May 1, 1984

Subject: Oyster Creek Nuclear Generating Station  
Docket No. 50-219  
Oyster Creek Cycle 10 Reload Application  
General Electric NEDO 24195  
Response to NRC Request for Additional Information

Fig. 1 Histogram used in statistical analysis for P8x8R reloads.

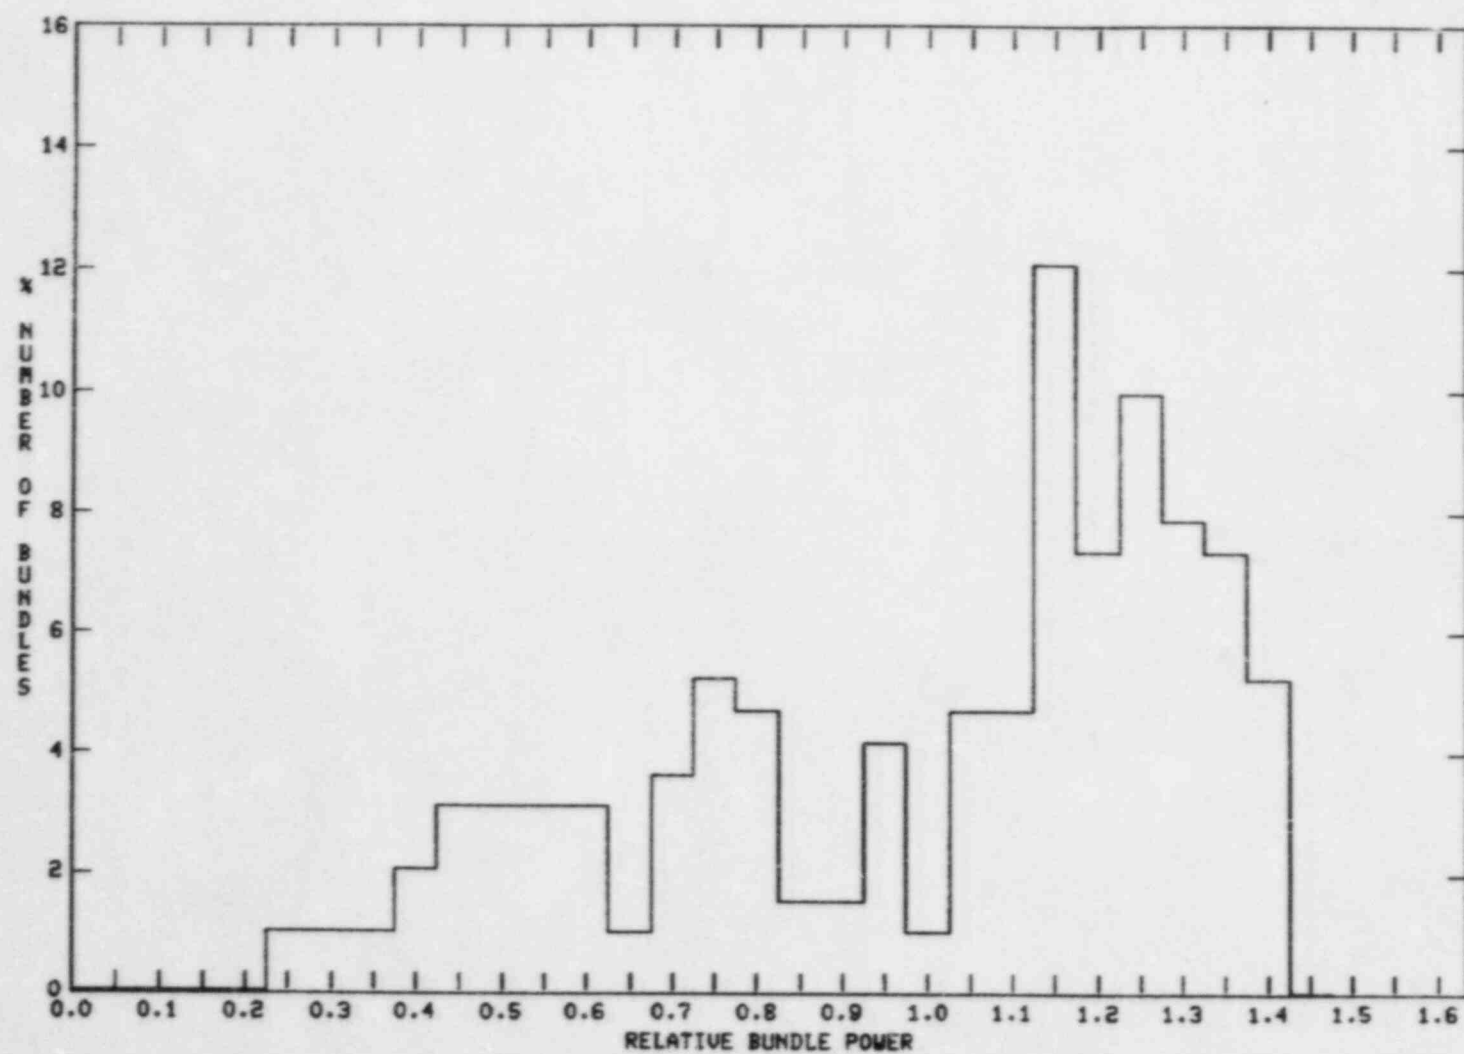
Supply additional information which demonstrates that the large core reload analysis applies to the Oyster Creek reloads. Also demonstrate that the bounding analysis is conservative though some of the plant unique uncertainties for Oyster Creek are greater than those required in the generic reload application NEDE-24011-P-A, "General Electric Reload Application."

The reactor core selected for the statistical analysis is a 251/764 reload core. The large core analysis results conservatively apply for a BWR-2. The histogram of relative bundle powers used in the statistical analysis is shown in Figure 1 (Figure 5-1 from NEDO-24195). The method to generate the power distribution is described in response to Question 492.2. For comparison purposes, the power distributions for the Oyster Creek reference cycle at BOC and EOC are shown in Figures 2 and 3. It can be seen that the statistical analysis power distribution is skewed more to the high power side than the Oyster Creek power distribution. Figure 4 is the CPR histogram for Oyster Creek. The statistical analysis CPR distribution has more bundles skewed to MCPR than the Oyster Creek CPR distribution. Therefore, the statistical analysis results for large cores would be conservative when applied to Oyster Creek.
